31/06-05O 10220 Carroll Place  
Kensington Historic District

RE: Patio/Hardscape Plan, 10220 Carroll Place, Kensington Historic District, Lot 29, Block 8, being a resubdivision of Lots 1 & 2, Block 8, Kensington Park

Re: Historic Area Work Permit # 396694  
10220 Carroll Place, Kensington, MD  
Primary 1 Resource within the *Kensington Master Plan Historic District*

2 SOUTH SIDE ELEVATION  
A4

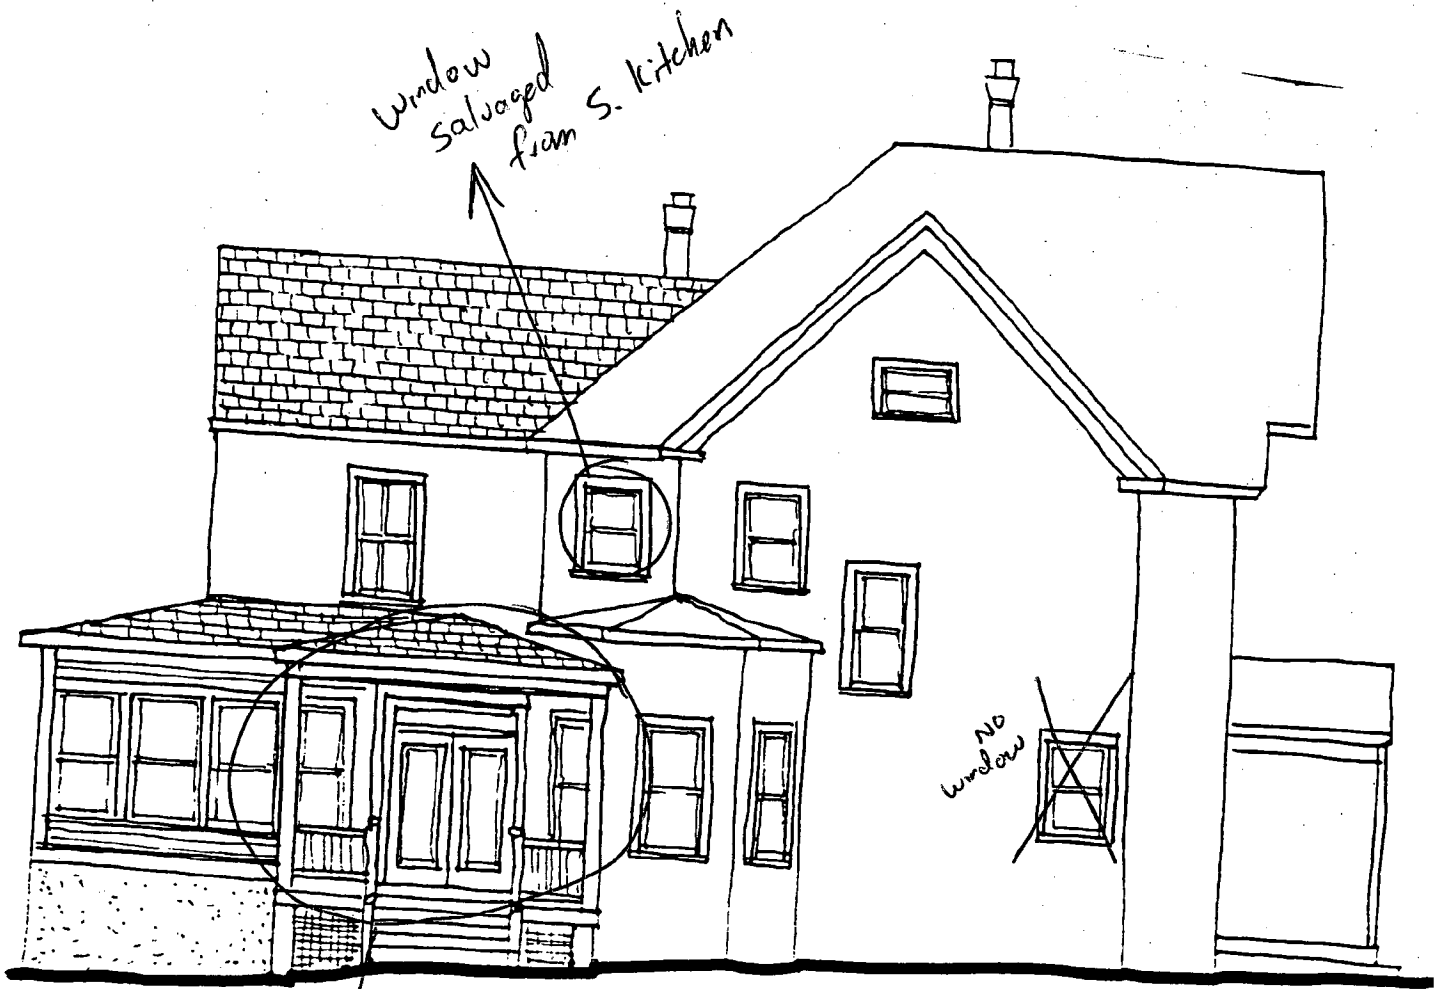
Porch not carried over to HAWP.

NORTH ELEVATION

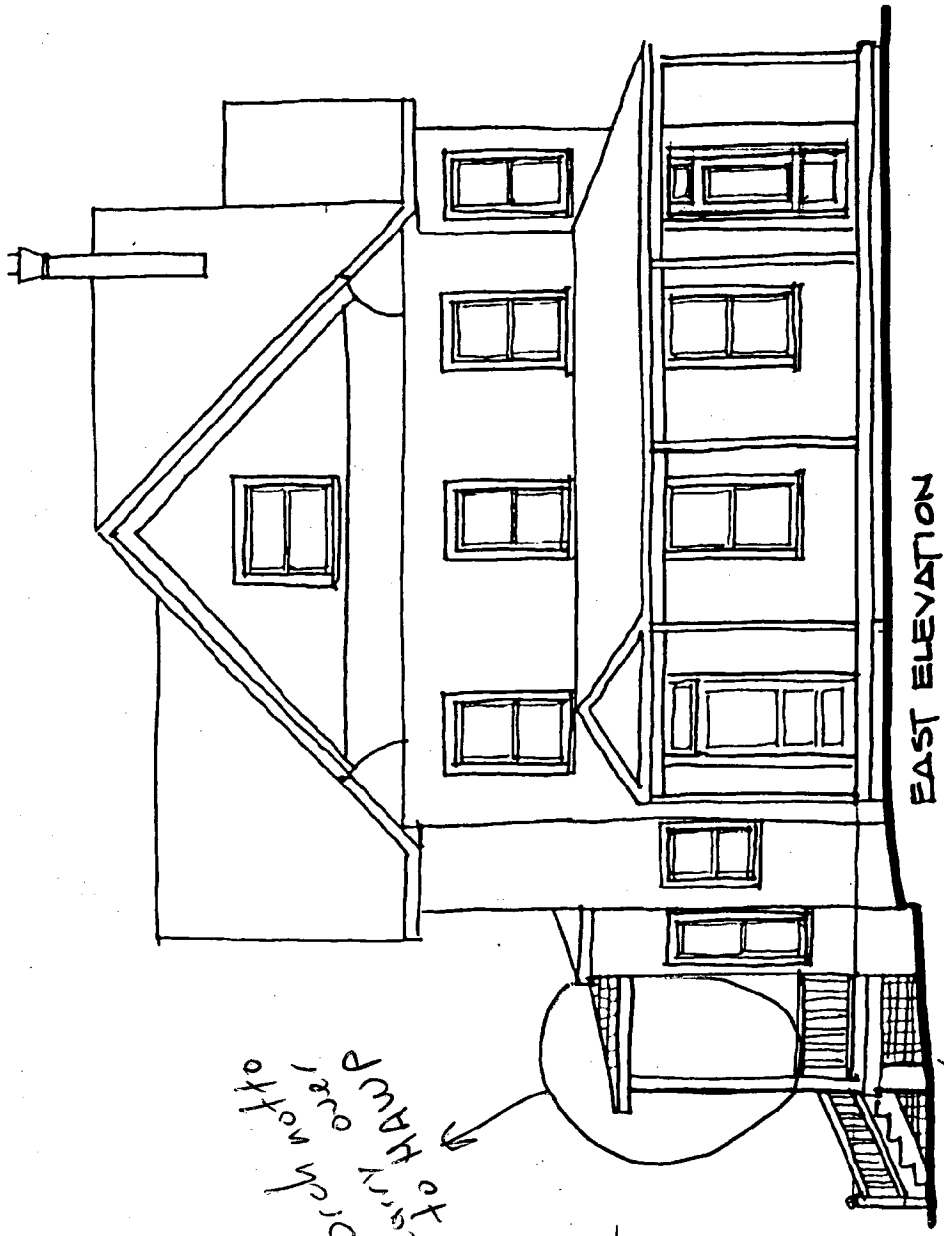
Steps  
might go  
to North  
↑

FRONT EAST ELEVATION

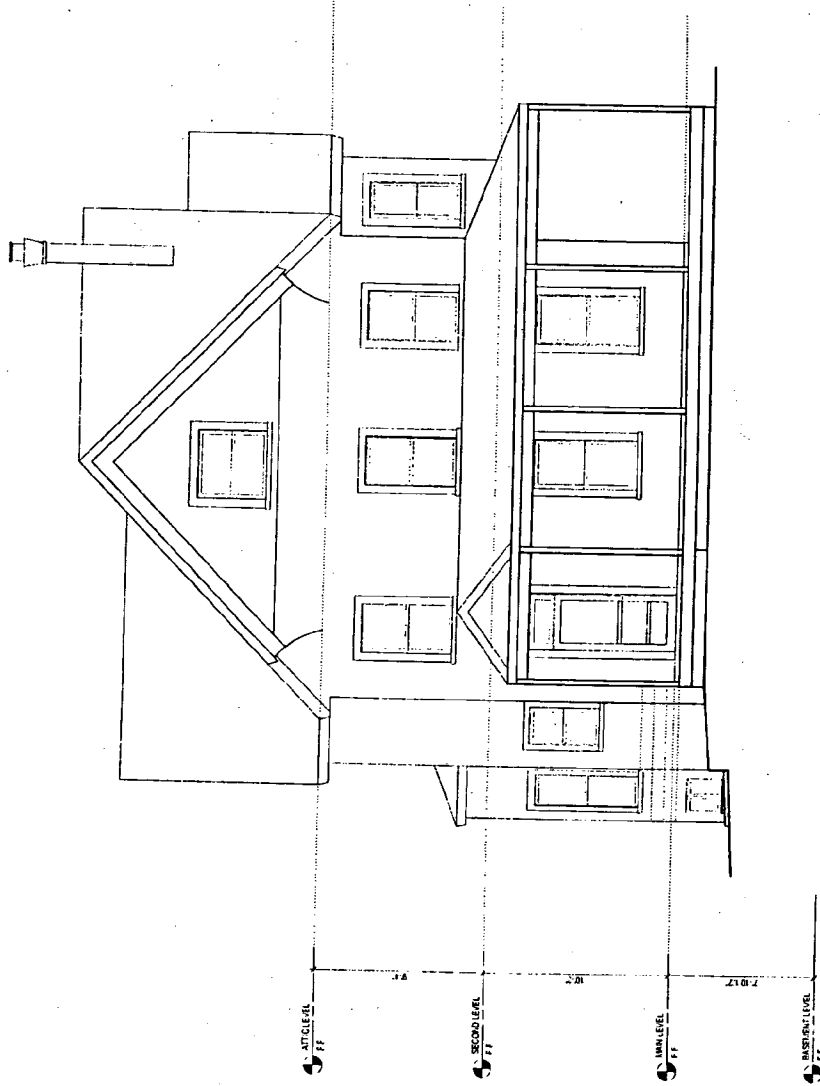
Porch over,  
carry over  
to HAWP

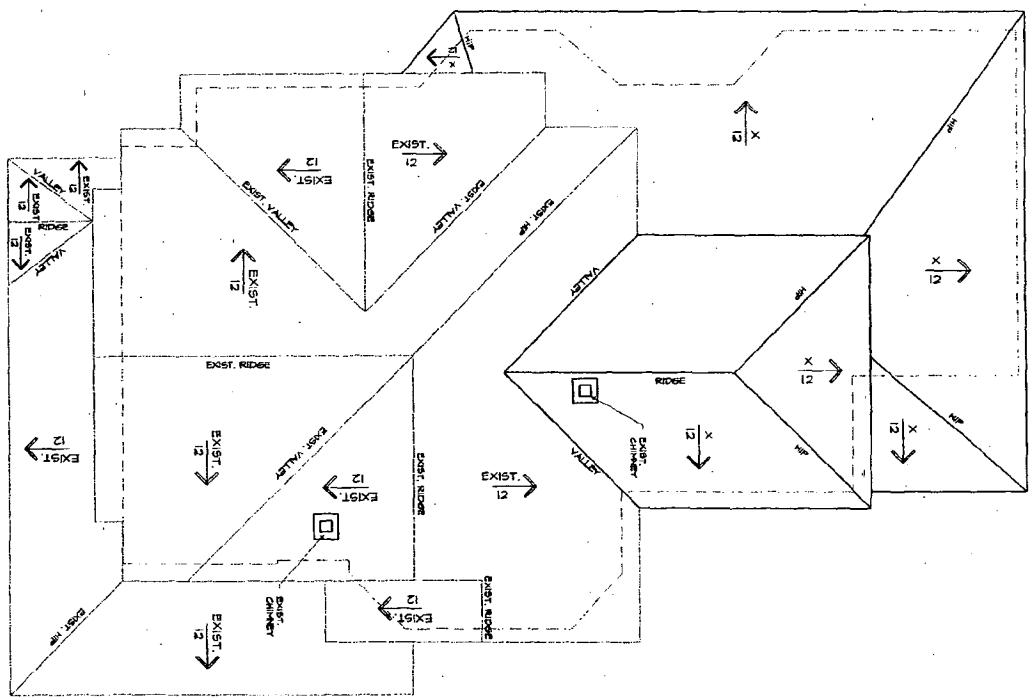
I am the contractor for Jim Engel and Maureen Conley, whose project goes up before the review board this evening. I will not be able to be there but wanted to try to clarify why the roof of the bay window has been lowered and incorporated into our design. To get an appropriate pitch and interior ceiling height for our shingled roof adjacent to the bay window it needed to be configured as is. If the bay roof were left as is, there would be a sidewall condition back where the bay roof met the side "gable wall" of the new roof and a possible water trap area. If we were to extend the plane of the new roof all the way to the corner and have it extend down it would lap over the bay roof and part of the bay roof would be overbuilt, necessarily concealing that part. A third element is the fact that the fascia of the bay would not line up with the new fascia and also at this point the bay roof would drain into the side of that overhang area creating another potential water problem.
